Technical Bulletin

HAMMOND ORGAN

SUBJECT: CIRCUIT PROTECTION FOR ZENER DIODE, D-301

30 E-300

Terminal strip just
below Pedal Divider
Board

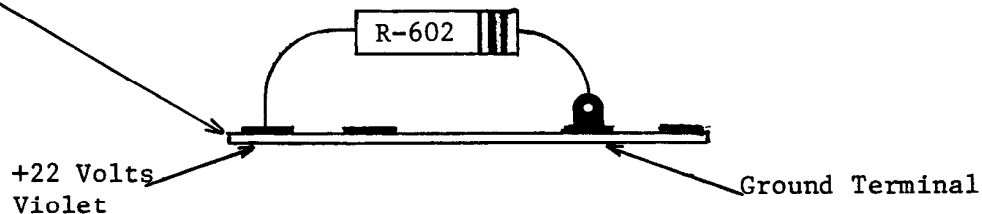
If you find it necessary to replace D-301; 22 Volt Supply Control Doide, we recommend adding resistor R-602; 1000 ohm, 2 watt, to the circuit as shown below. This diode is located in the Power Supply Section of the large chassis on the Console floor.

NOTE: Because the addition of this resistor is a simple matter, it is recommended you make this revision on all E-300 instruments you encounter.
